City of Alachua

Staff Report

SUBJECT: A request for a Site Plan for a ±158,562 square foot building for retail sales and services, with associated parking, stormwater management facilities, utility infrastructure, and supporting site improvements

**CITY OF ALACHUA
STAFF REPORT: WAL-MART #3873
SITE PLAN**

Illustration 1: Sheet C-6 of the Proposed Site Plan

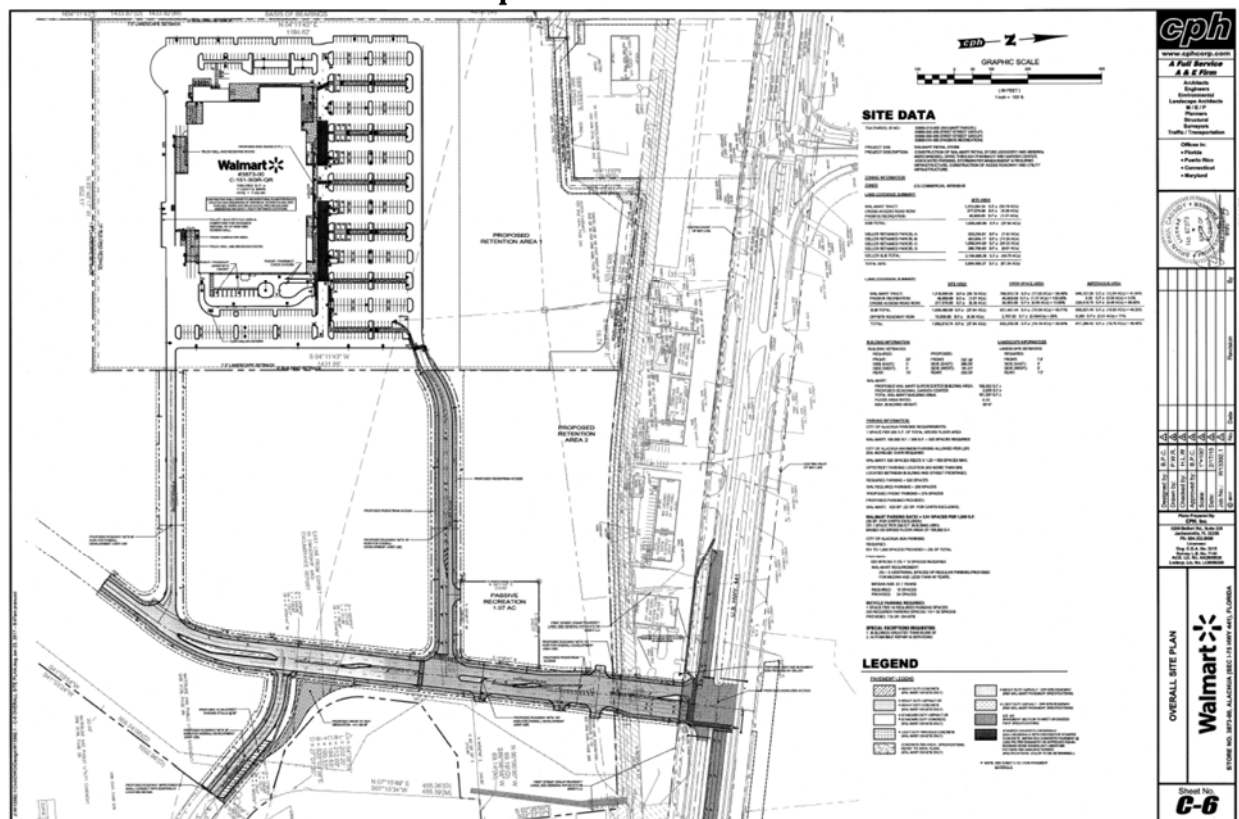
- (f) Sheet C-3B: Many spot elevations not legible due to overlap of information on drawing.
- (g) Sheet C-6: Add Tax Parcel No. 03066-000-000 under Site Data.

- (h) Sheet C-6: Impervious Area for parcel currently labelled “City dedicated parcel” is 0 square feet. Revise accordingly.
- (i) Sheet C-6: There is a typographical error under “Special Exceptions Requested.”

- (j) Sheet C-6: There is a typographical error under “Conditions,” first bullet.
- (k) Sheet C-6: There is a typographical error under “Conditions,” third bullet, second line (“location” should be plural.)

- (l) Sheet C-6: “Conditions,” third bullet: verify the information is correct pertaining to rainfall to be treated.
- (m) Sheet C-6A: Keynotes: Identify detail sheet where detail for each keynote is provided.
